UNITED STATES PATENT AND TRADEMARK OFFICE

APPLICATION NO.	FILING DATE	FIRST NAMED INVENTOR	ATTORNEY DOCKET NO.	CONFIRMATION NO.
10/754,546	01/12/2004	Jae-Bon Koo	6161.0118.US	9275

Office Action Summary

DETAILED ACTION

- Front View of Amorphous Semiconductor during Laser Crystallization

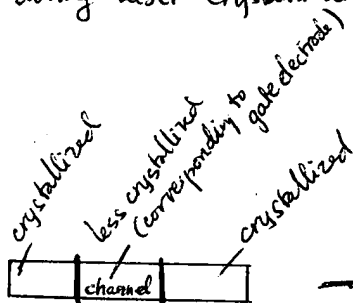
Examiner's response: Conventionally, when forming channels (for thin film transistors) from the amorphous semiconductor layer, the gate electrode was usually used as a mask. Therefore, after laser crystallization, the amorphous semiconductor layer became polycrystalline semiconductor layer with regions of crystallized and region of less crystallized. The heterogeneous straight lines were at the boundary of the regions of crystallized and region of less crystallized, [see figures from attachment provided by Examiner in this Office Action]. The figures that Examiner cited from Ohtani reference (from previous Office Action) were the evidence of forming the channel (for thin film transistor) from the amorphous semiconductor layer, and the heterogeneous straight lines inherently formed after laser crystallization.

laser crystallization

→ the lines at the boundary of the regions of crystallized & region of less crystallized are heterogenous straight lines.
